URGENT MEDICAL DEVICE CORRECTION

July 26, 2023

Problem Description Baxter Corporation is issuing an Urgent Medical Device Correction for the Novum IQ large volume pump (LVP) due to the potential for internal screws becoming loose and damaging the pumping mechanism valves. A loose screw within the Novum LVP device that results in damage to the pumping mechanism valves can cause an over infusion.

Figure 1: Rotate Door Open and Shut to confirm Valve movement

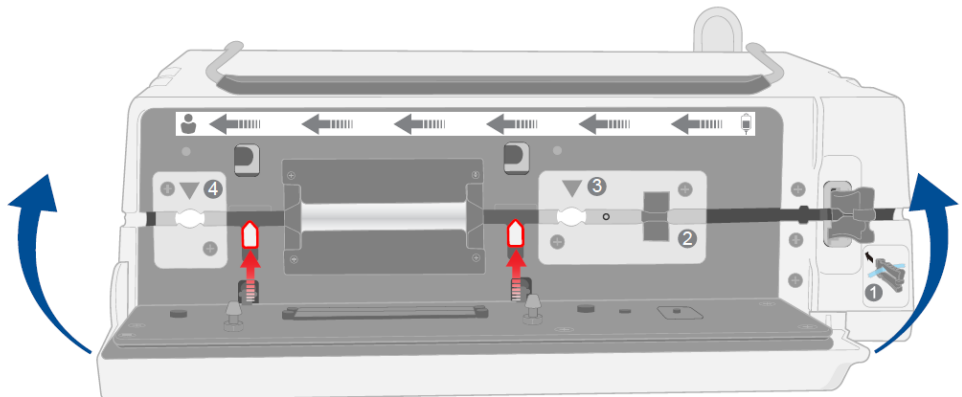
- Operators may continue to use the Novum IQ LVP. Prior to use, confirm pumping mechanism valves (outlined in red in Figure 1) are not stuck and move up and down as the Novum IQ LVP door is rotated open and shut. If the mechanism valves are stuck or not moving up and down with the rotation of the door, immediately discontinue the use of the device.
